SUBJECT: **Public Hearing for Final Site Plan & Special Land Use Permit at 243 E. Merrill – La Strada Caffe**

LA STRADA CAFFE
243 E. MERRILL
SPECIAL LAND USE PERMIT
2015

SUBJECT: **Final Site Plan & Special Land Use Permit Review**
243 E. Merrill – La Strada Caffe

Drawing Title
FRONT ELEVATION

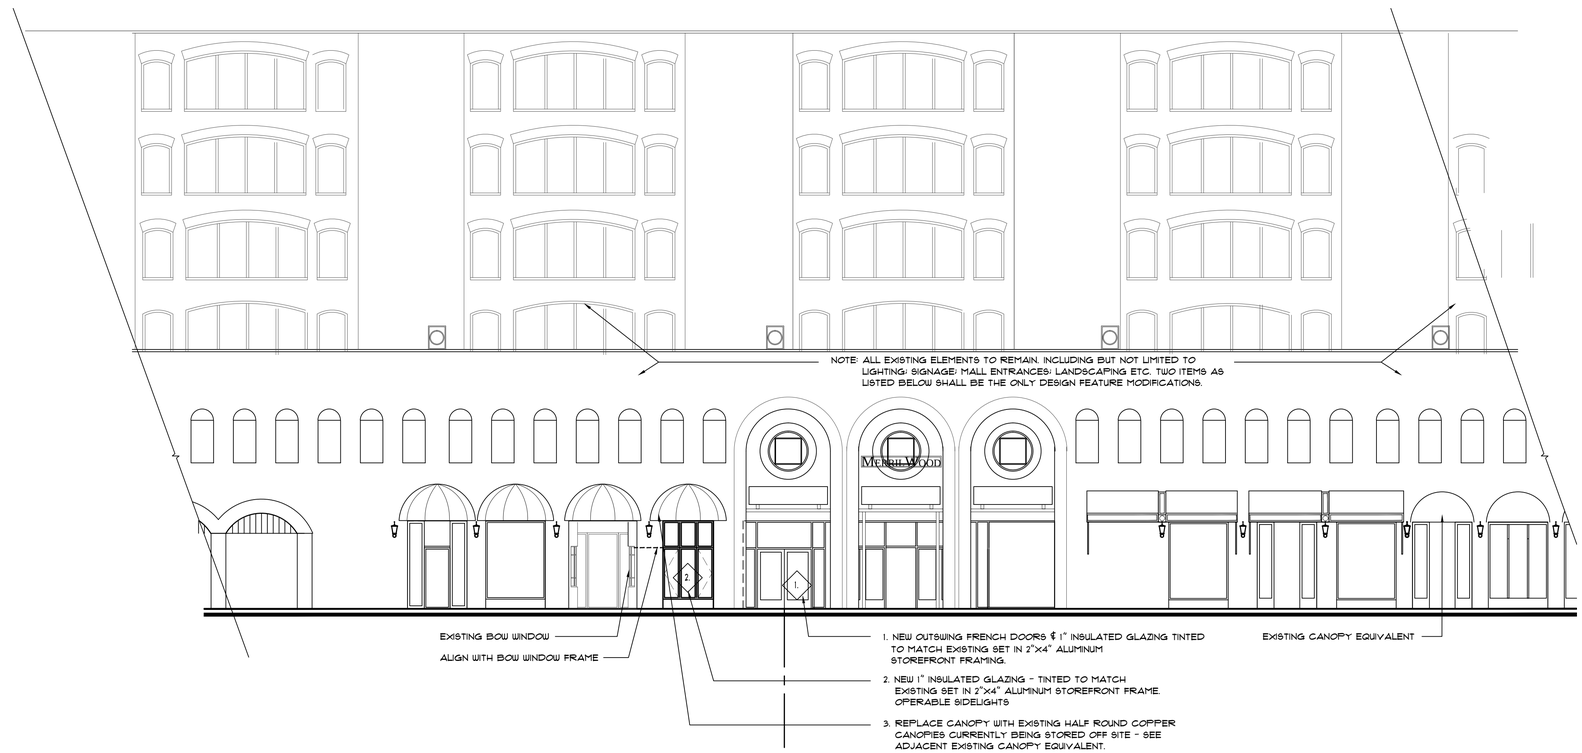
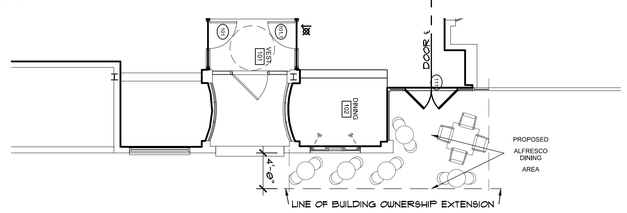
DINING AREA SHALL BE HELD TO WITHIN 4' OF THE "BUILDINGS OWNERSHIP EXTENSION" AND SIDELINES AS ILLUSTRATED AT ENTRANCES.

DESIGN CHANGES REQUESTED

FURNITURE LAYOUT

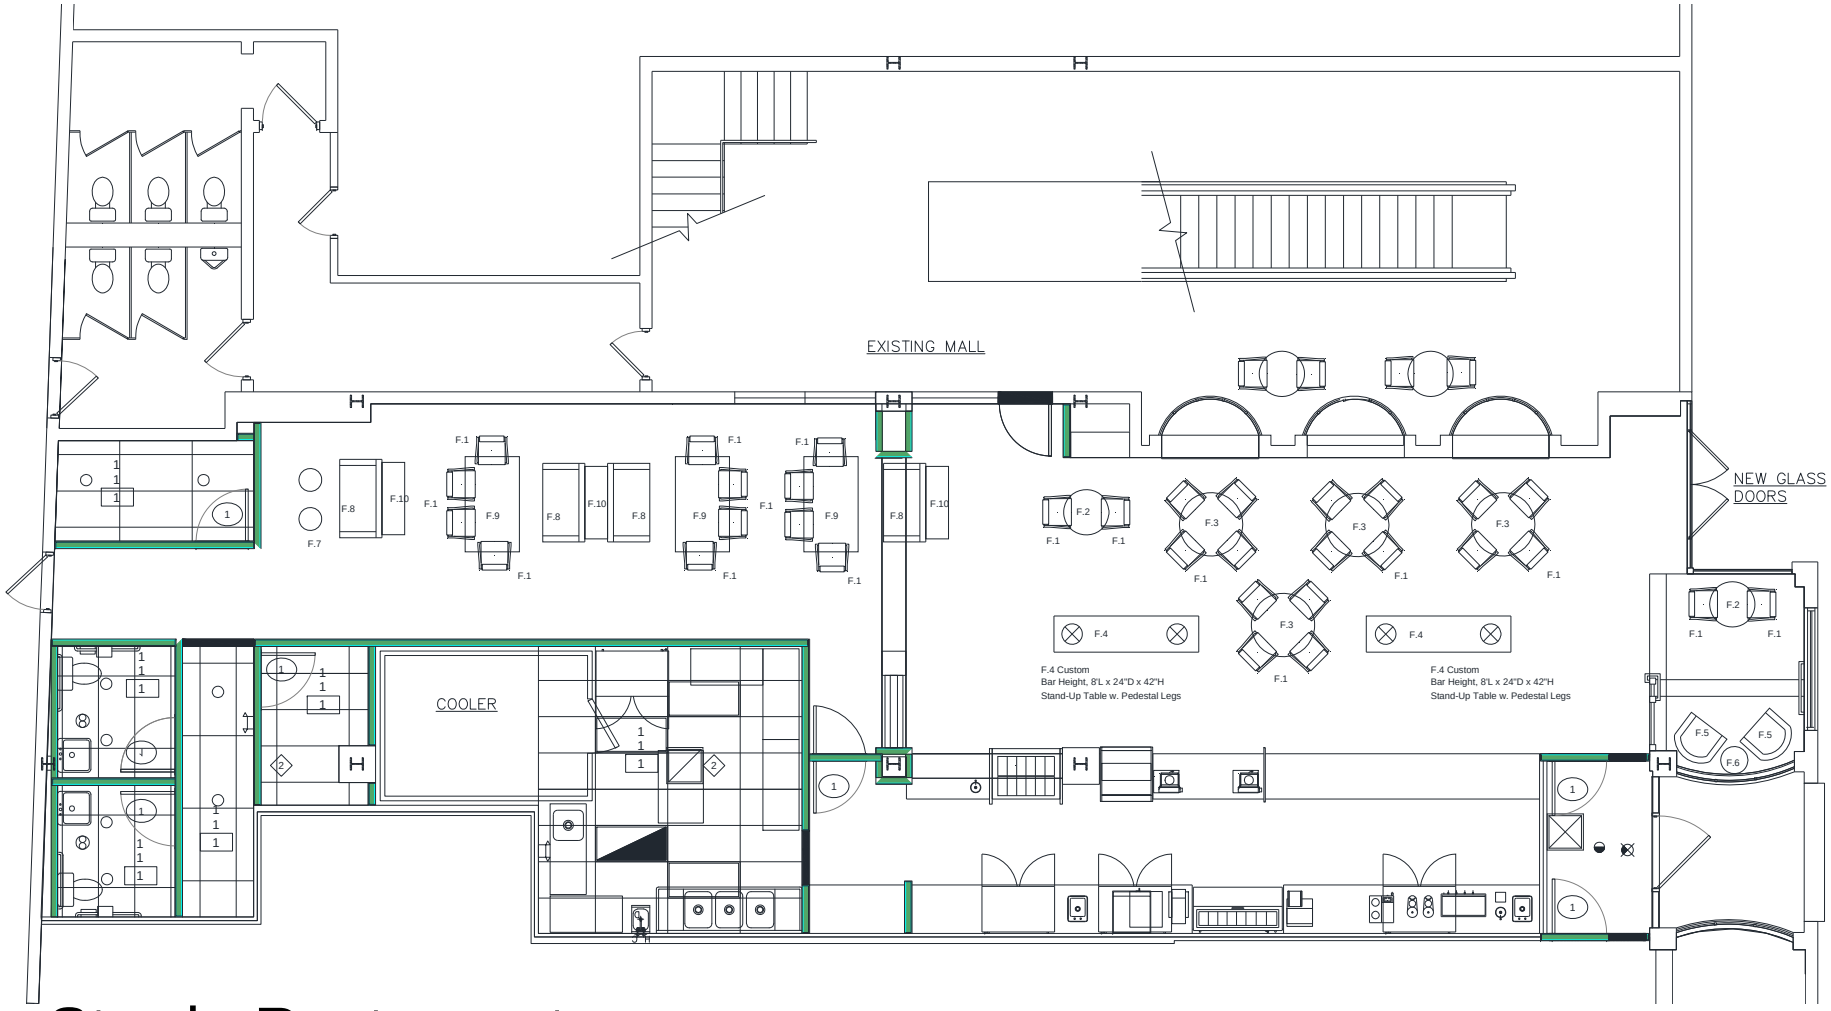
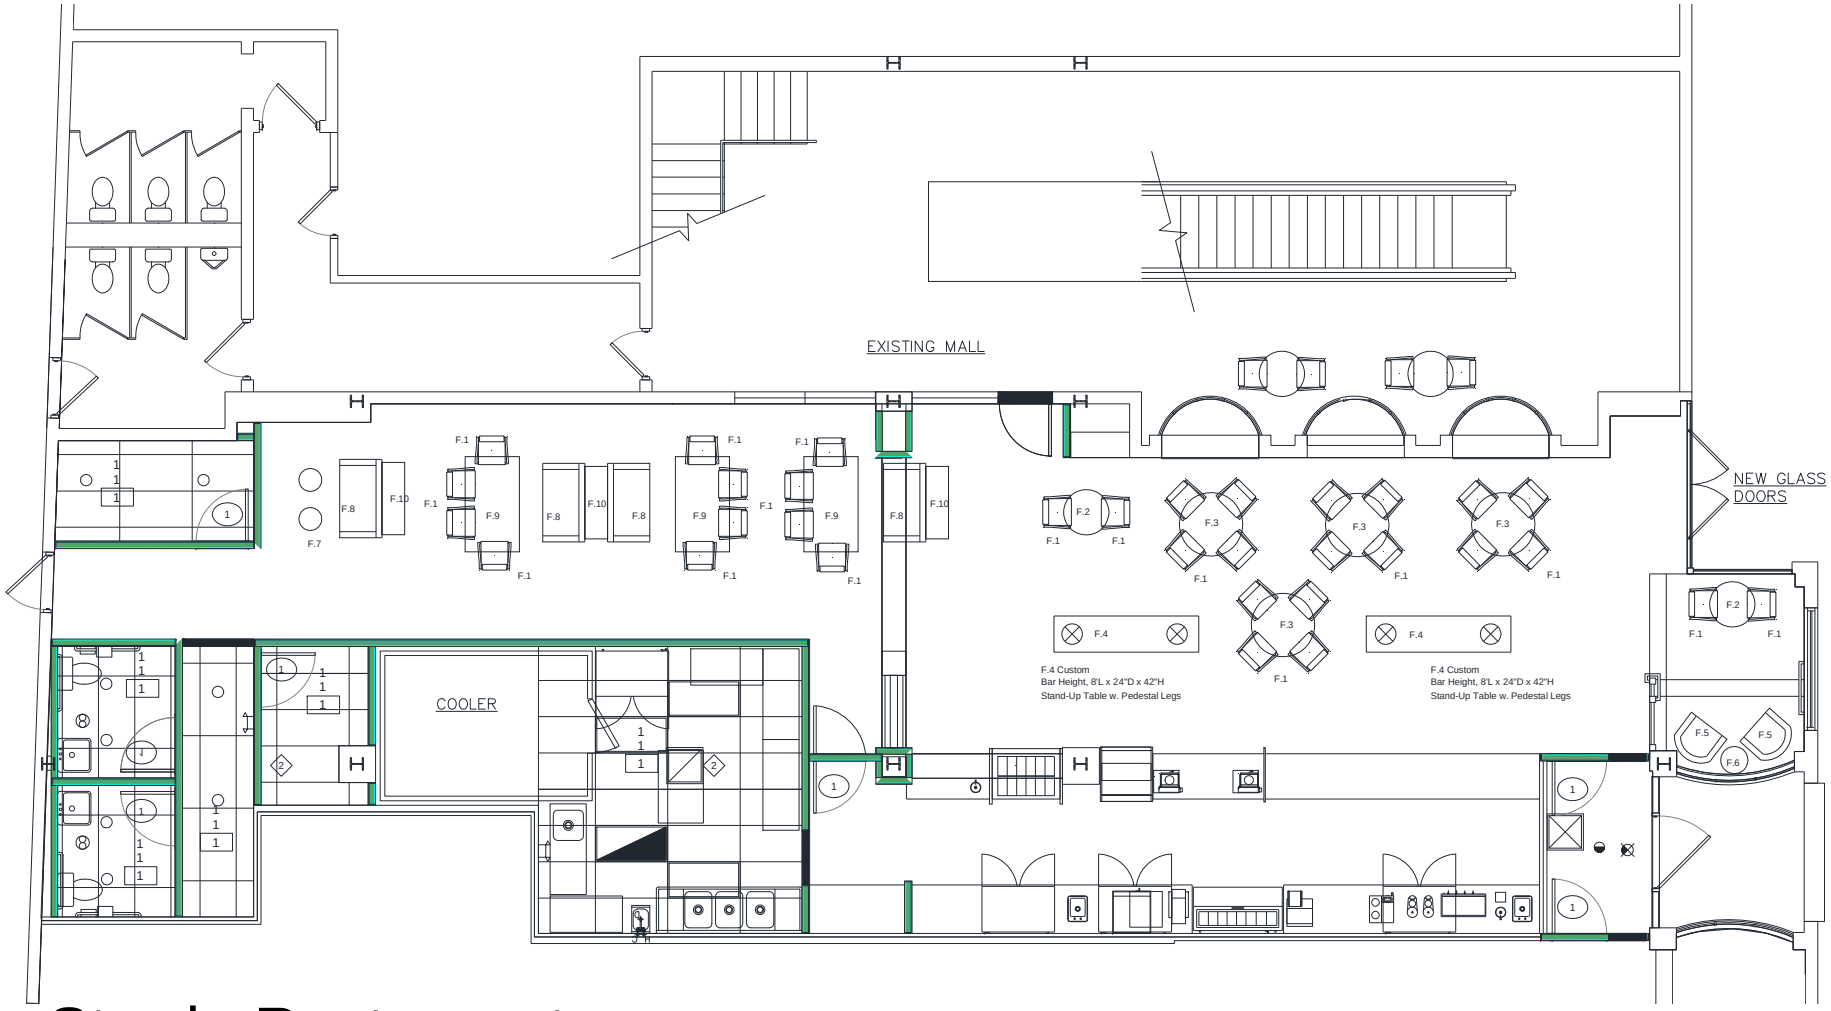
Ms. Whipple-Boyce pointed out that the furniture layout will not fit into the small space shown on the outdoor seating plan.
